City of Franklin

Meeting Agenda

Historic Zoning Commission

Monday, September 14, 2026

CORNERSTONE PRESBYTERIAN CHURCH HISTORIC ZONING COMMISSION - SUBMITTAL

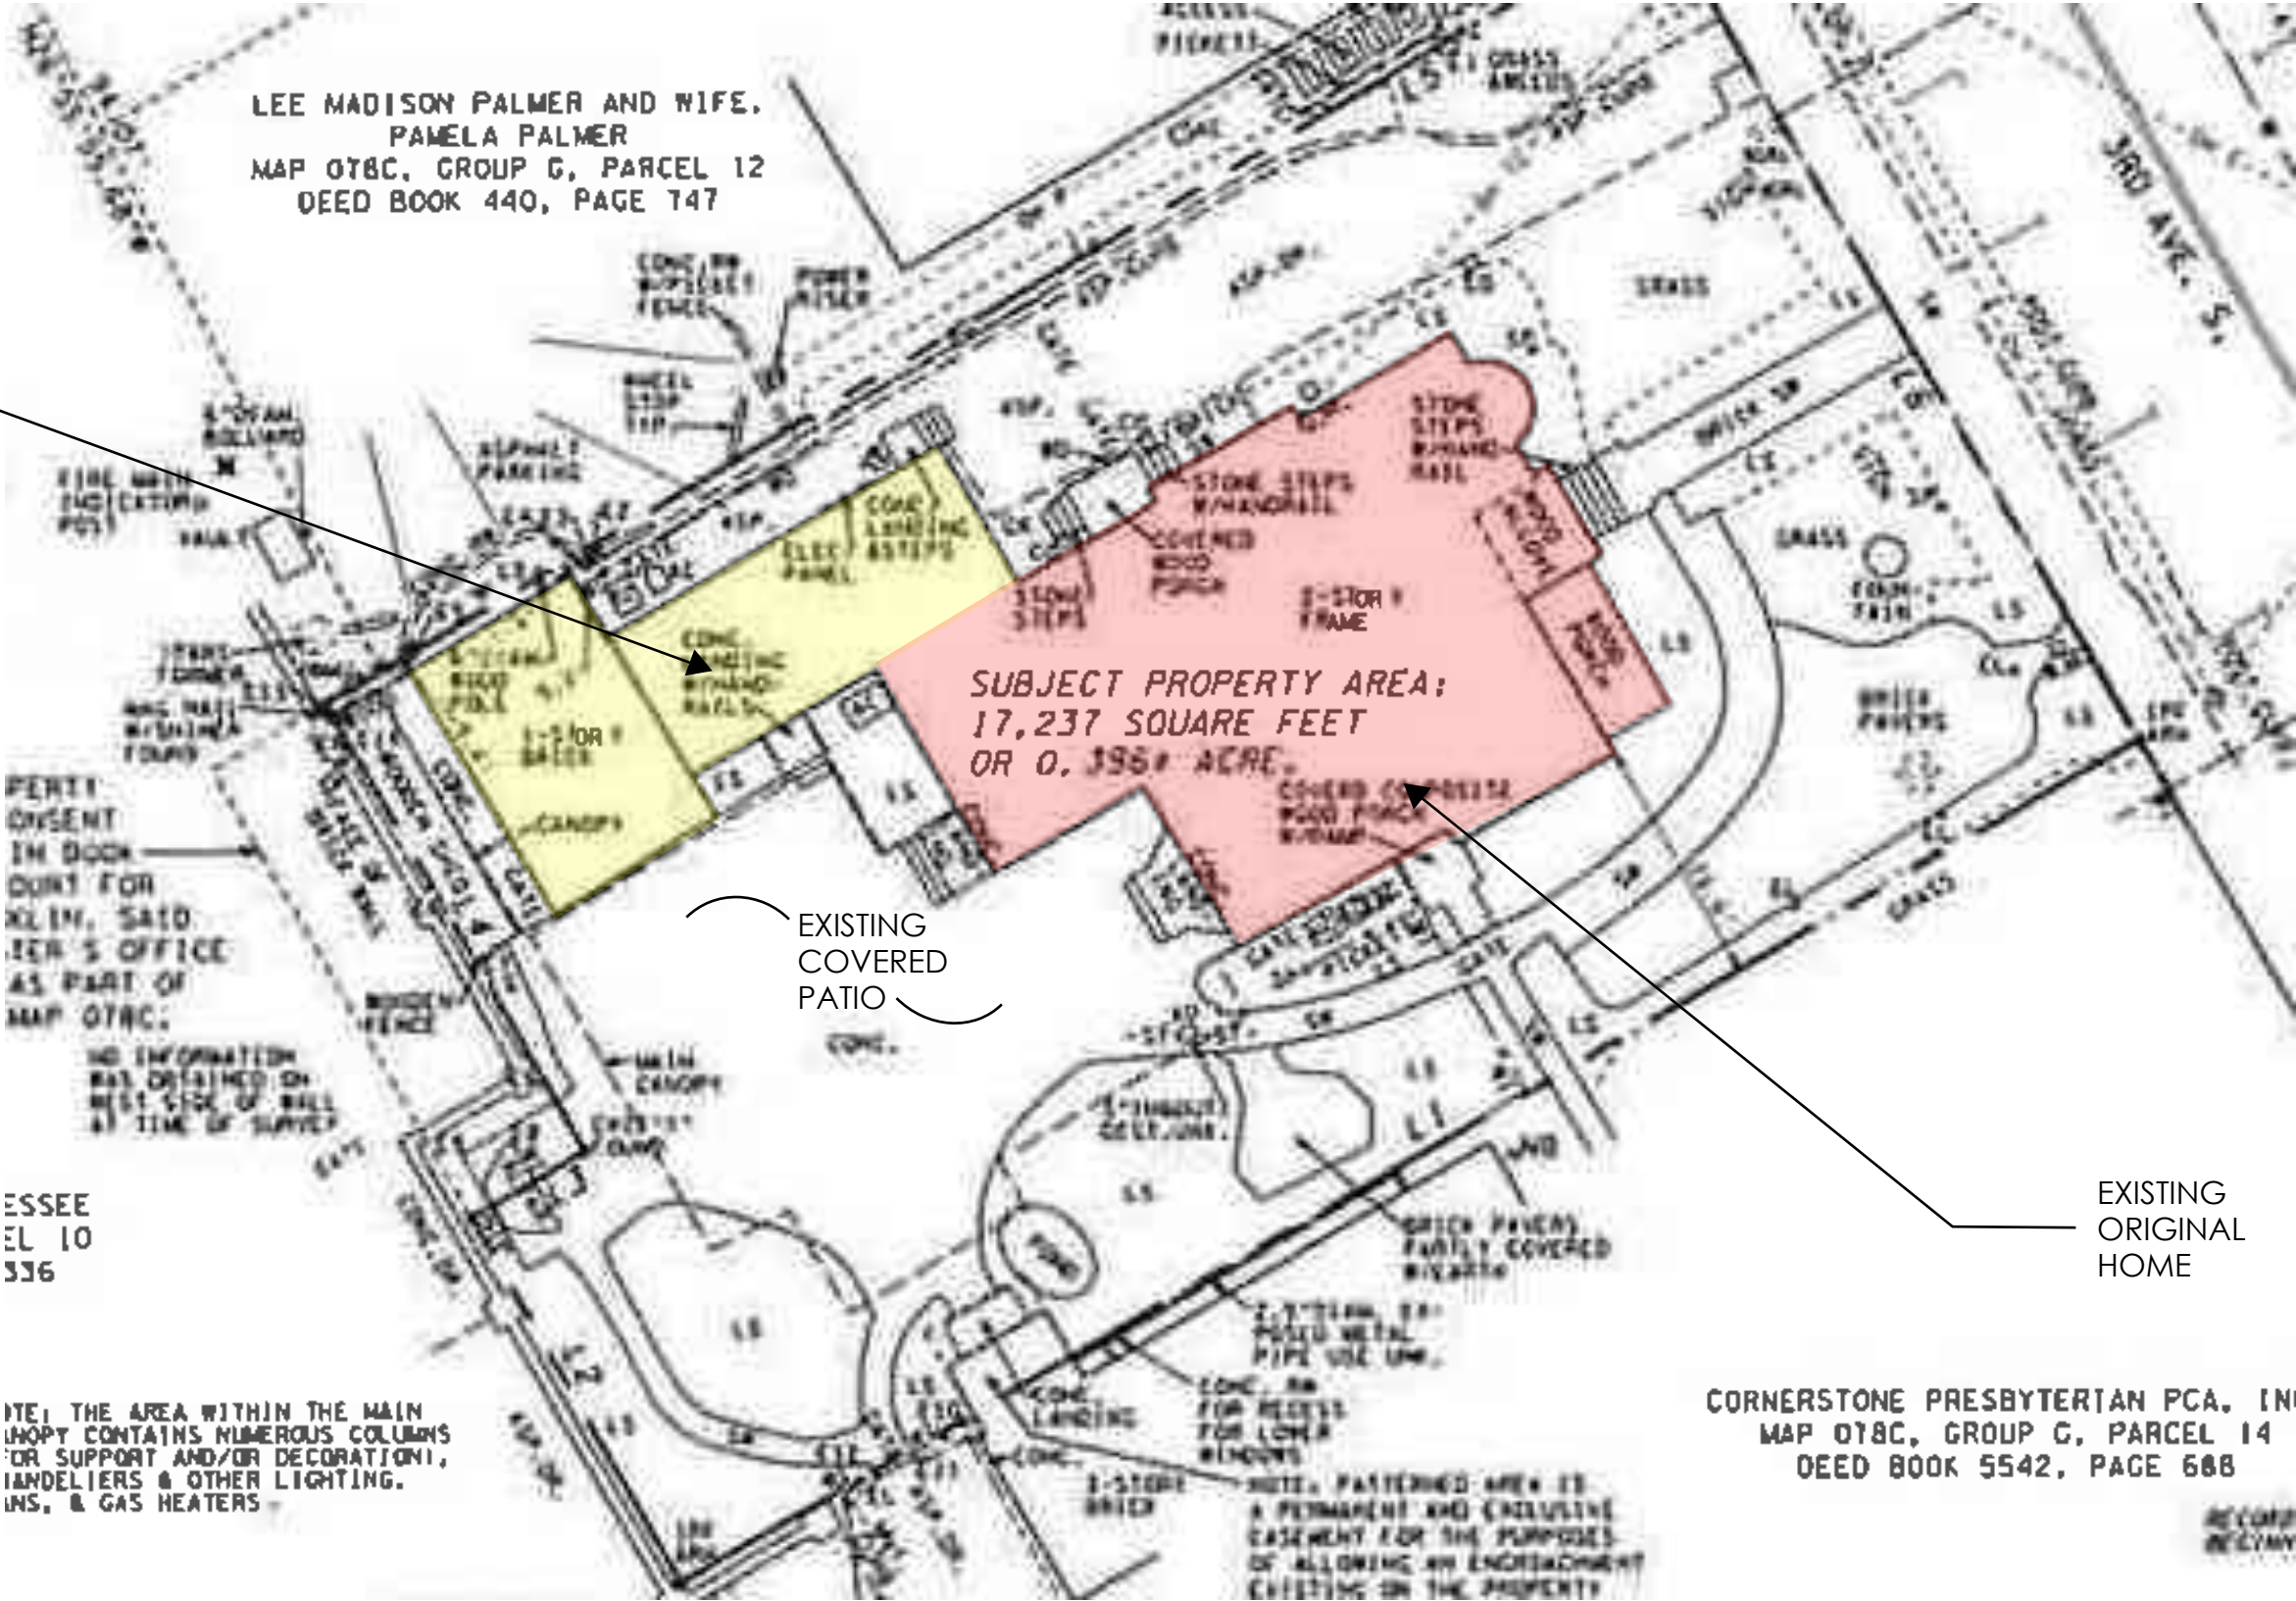
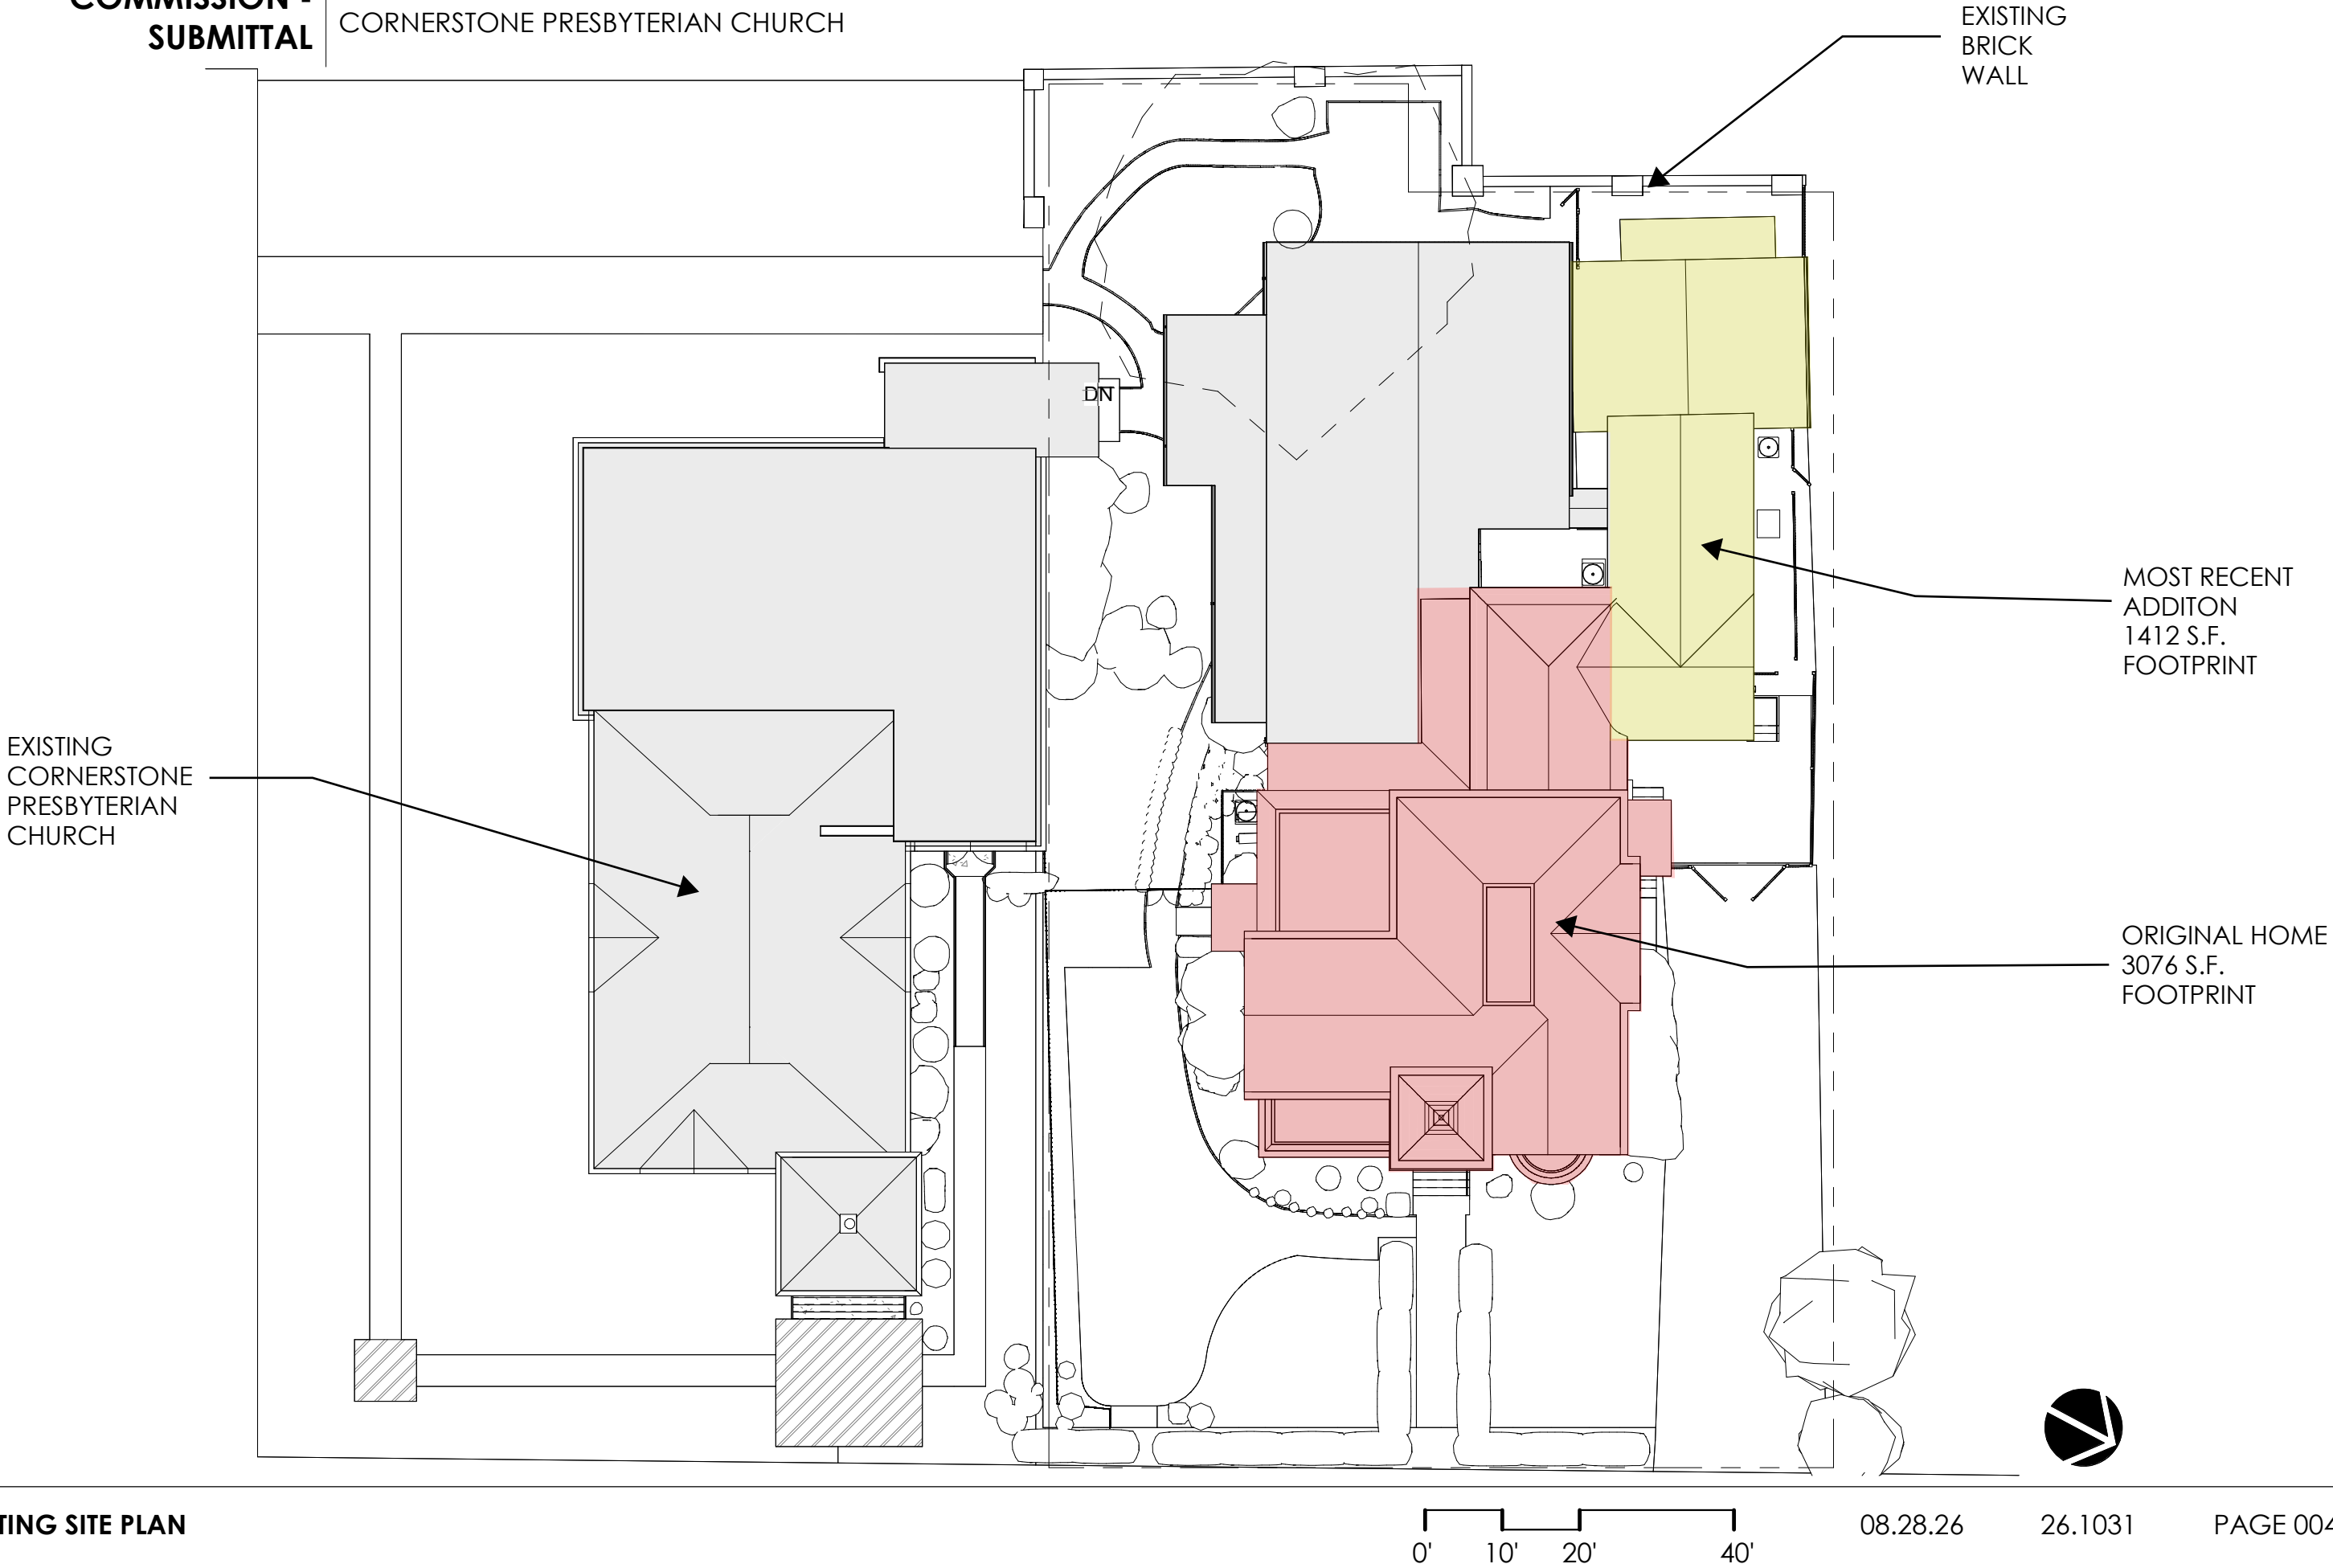
The first is the addition of hardscaping around the building. The hardscaping visible from 3rd Avenue South appears to consist of a dark red paver, and to the rear of the site, concrete will be used. Both of these materials are supported by the Guidelines. However, their placement is unique, as the Guidelines recommend that, for residential buildings, a landscaped front yard be provided and paved or hardscape areas be minimized. Traditional lawn areas should not be replaced with hardscaping. The left side of the building has added hardscaping that measures 20' in width. The amount of hardscaping in the front yard should be minimized to align with the Guidelines.

At the rear of the property is an existing 7' tall brick wall. It is proposed to match the design of the wall and include a wrought iron gate on the right side of the property, where the driveway is located now. The wall and gate align with the Guidelines recommendations. However, the design of the gate was not included and should be returned to the Preservation Planner for review to ensure it has traditional characteristics.

It is proposed to restore the historic building and remove the existing aluminum siding with an 8" exposure and replace the siding with painted wood siding. The new siding is proposed to be 6" in exposure. The exposure should be consistent with what was historically on the building, if any siding remains. The siding should be restored if intact. If the siding is not there, new lap siding with an exposure of 4" is recommended as that is consistent with the architectural style of the building. The Guidelines support the removal of synthetic siding, restoring the original siding materials, and installing new siding.

It is proposed to remove the rear addition on the building and the tent structure at the rear of the building. The addition is believed to have been constructed circa 1990 and the age of the tent structure is circa 2000. The Guidelines support removing both.

1. The hardscaping in the front yard should be minimized to align with the Guidelines. The hardscaping and landscaping plan shall return to the Preservation Planner for review and approval.

2. The wrought iron gate design shall return to the Preservation Planner for review and approval.
3. The exposure of the lap siding shall be consistent with what was historically there, if it cannot be repaired. If it cannot be restored and new siding should be installed, it must have an exposure of 4".

4. The windows must have a historic profile and dimensions and consist of either wood or a composite material with the appearance of wood. The window and garage door specifications must be approved by the Preservation Planner or the HZC prior to issuance of a building permit.
